Contract #: 04-0120R4
 Cty: SF Rte: 80 PM: 12.6,13.2
 File #: 11.25B

QUALITY ASSURANCE -- NON-CONFORMANCE REPORT

Report No: NCR-000015

| Joint fit-up | Coating | Other | Component: Skid Beam B (FCM) |

Reference Description: Heat straightening with active force not a step in TMF 's heat straightening procedure.

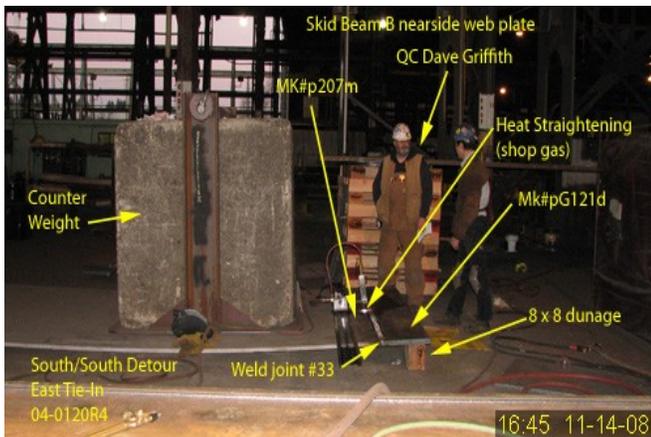
TMF Quality Control Inspectors Roger Fife & Dave Griffith have allowed TMF production to perform Heat Straightening (HS) with active force on 11-14-2008 at Skid Beam Nearside Web – WB207A (side a). The use of counter weights is not a step in the TMF approved heat straightening procedure. TMF production has also performed heat straightening on the same locations at two separate times. The following are locations of heat straightening application from Day Shift and the Swing Shift:

Day Shift: The application of heat was applied from the center line of the weld 2-3/4" (1 Pass) and 3-1/4" (1 pass) on the FCM plate MK#p207m.

Swing Shift: The application of heat was applied from the center line of the weld 2-3/4" (1 Pass) and 3-1/4" (1 pass) on the FCM plate MK#p207m.

As of this time TMF QC did not provide a heat straightening report for the initial heat that was induced in the material on day shift of 11/14/08 showing extent and effectiveness of heat straightening.

TMF submitted a response stating that the use of weights was used as a one time exception and TMF would follow approved procedure in the future (Ref 215-STT-.02243)
